**PLANNING & ZONING SECTION  
STAFF REPORT**

<b>Dates:</b>	<b>P&amp;Z: 09/30/24</b>	<b>BCC: 10/15/24</b>
<b>Case Number</b>	241007ZP	
<b>CDP-AR</b>	31847	
<b>Type of Case – Rezoning</b>	<b>FROM:</b> General Agriculture (A-1), Community Business (B-2), Regional Business (B-4), and Heavy Business (B-5) <b>TO:</b> Planned Unit Development (PUD)	
<b>Owner/Applicant</b>	Florida Investment Fund of Birmingham, LLC; Simeon Holdings, LLC; Optimum Dealership Group, LLC; Investment Co. of Florida, LLC; W. Gary & Pamela D. Turnley	
<b>Street Address / Site Location</b>	West side of S. US Hwy 27/301/441, lying between SE 73 <sup>rd</sup> Street and SE 80 <sup>th</sup> Street	
<b>Parcel ID Number(s)</b>	36474-000-00, 36474-001-00, 36475-000-00, 36547-000-00, 36547-001-00, 36547-002-00, & 36514-000-00	
<b>Property Size</b>	36474-000-00 – ±8.02 AC, 36474-001-00 – ±2.22 AC, 36475-000-00 – ±2.8 AC, 36547-000-00 – ±11.30 AC, 36547-001-00 – ±6.61 AC, 36547-002-00 – ±26.63 AC, 36514-000-00 – ±24.27 AC TOTAL - ±81.85 AC

**Figure 6 - North PUD Area  
Enabled Zoning and Maximum Floor Area Ratio (FAR)**

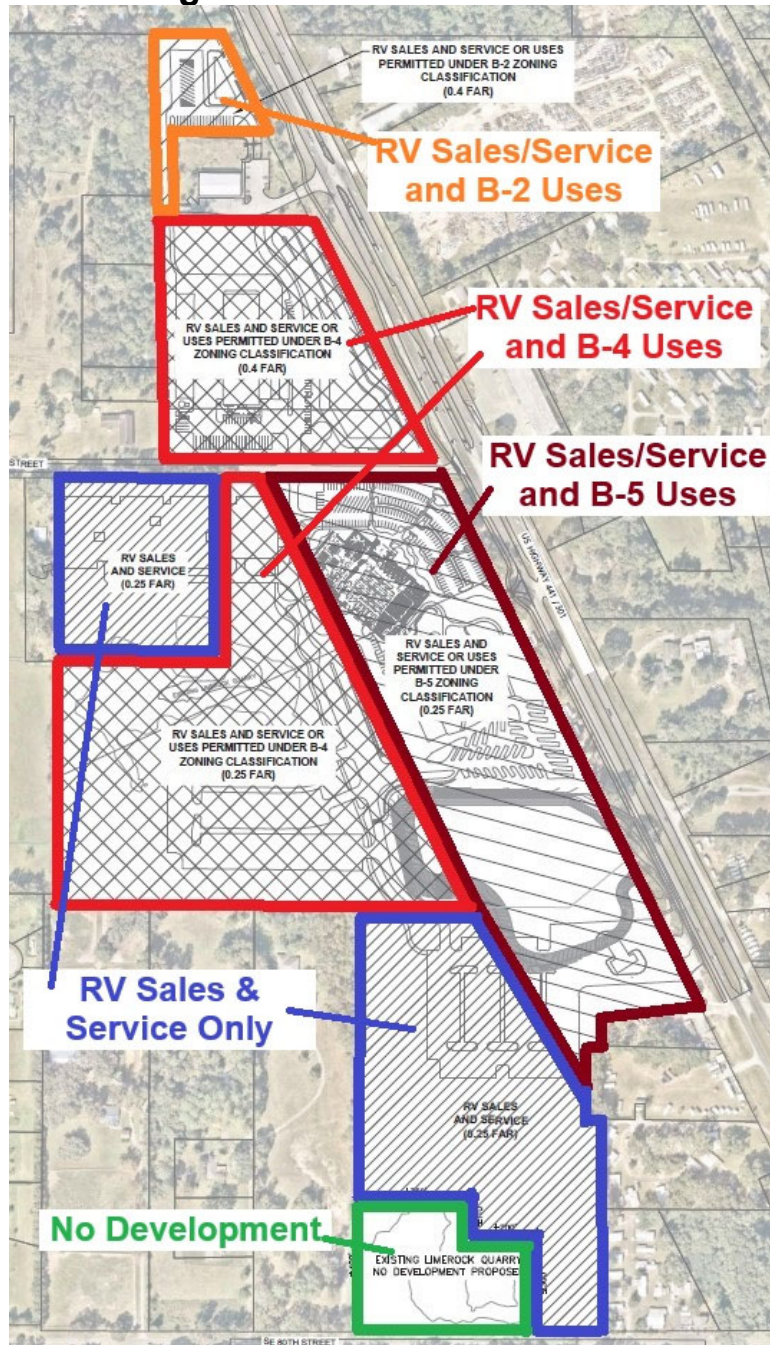
Figure 6 following illustrates that the PUD proposes generally enabling "RV Sales and Service" throughout the PUD, while enabling Community Business (B-2), Regional Business (B-4) and Heavy Business (B-5) uses in those areas of the PUD currently zoned B-2, B-4 and B-5 respectively. For the areas not currently subject to an existing commercial zoning district classification, the PUD would then be limited solely to "RV Sales and Service" with no other commercial uses permitted. Further, at the PUD's southwest corner along SE 80<sup>th</sup> Street, across from the Santos Trailhead Complex, an area of no development I proposed where a historic limerock mine area is located. (See Figure 6, and/or Attachment B, Sheet C004). Ordinarily, the site's Commercial future land use designation allows a floor area ratio (FAR) of up to one (1); however, the PUD proposes establishing reduced maximum floor area ratios based on whether the location is north or south of SE 73<sup>rd</sup> Street. For the north PUD area, a maximum 0.40 FAR is proposed, while for the south PUD area, a maximum 0.25 FAR is proposed. Staff notes that buildings/structures are calculated for FAR; however, parking lots/areas are not calculated as part of the FAR, although such areas are calculated as part of a site's impervious surface.

- *The PUD's uses shall conform to the authorized uses and maximum floor area ratio (FAR) standards as listed and illustrated on the PUD Conceptual Master Plan Sheet C004.*
- *No on-site public address (PA) systems shall be utilized.*
- *All vehicle repair and/or service work shall be required to take place in a fully enclosed building with closed doors, wherein no repair work shall occur in open bays or bays with open doors.*

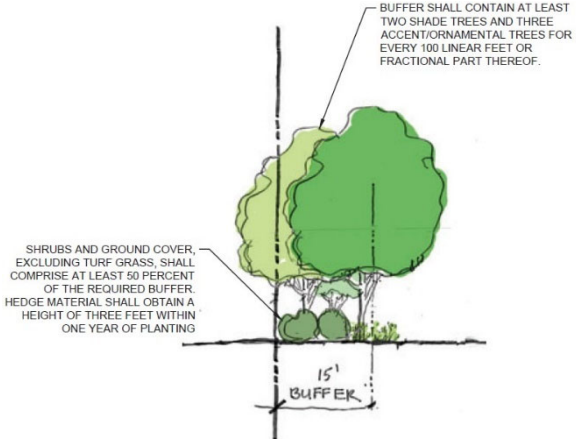
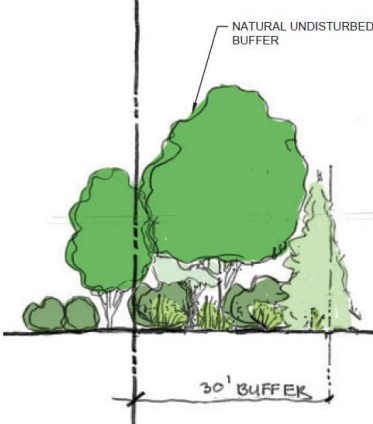
The PUD proposes four specific buffer types (See Attachment B, Sheet C006), with Type I providing for two alternative designs, and Type III representing where the PUD's adjoins commercially-designated or -developed properties, wherein no buffer is then proposed. Table C below provides the proposed PUD buffers with their accompanying illustrations, while Table D summarizes the PUD's required, proposed, and staff recommended buffers for the PUD:

TABLE D. BUFFER COMPARISON AND RECOMMENDATION				
Direction	Adjoining Use	Required	Proposed	Recommended
<b>West</b>	COM: Church  Vacant: Ag/Com	No Buffer  Type-B/D	<b><u>Modified Type-B</u></b> 20' wide without wall with 3 shade trees and 3 accent/orn. trees <b>OR</b> 15' Type-B (reduced width) with Wall	<b><u>Modified Type-B</u></b> 20' wide without wall with 3 shade trees and 3 accent/orn. trees <b>OR</b> 15' Type-B (reduced width) with Wall
<b>SOUTH PARCEL</b>				
<b>North</b>	COM: Church PUD Comm.	Type-C	Type-C	Type-C
<b>South</b>	COM: RV Sales, Shed Sales	No Buffer	No Buffer	No Buffer
	SE 73 <sup>rd</sup> Street	Type-C	Type IV – 30' Undisturbed ("No touch")	Type IV – 30' Undisturbed ("No touch")
<b>East</b>	US Hwy 441	Type-C	Type-C	Type-C
	COM: RV Sales, Shed Sales	No Buffer	No Buffer	No Buffer
	RVP/MHP	Type-B (w/wall)	Type IV – 30' Undisturbed ("No touch")	Type IV – 30' Undisturbed ("No touch")

<b>West (overall)</b>	Ag/Residential Tracts Legendary Trails	Type-D/B (w/wall)	Type IV – 30' Undisturbed ("No touch")	Type IV – 30' Undisturbed ("No touch")
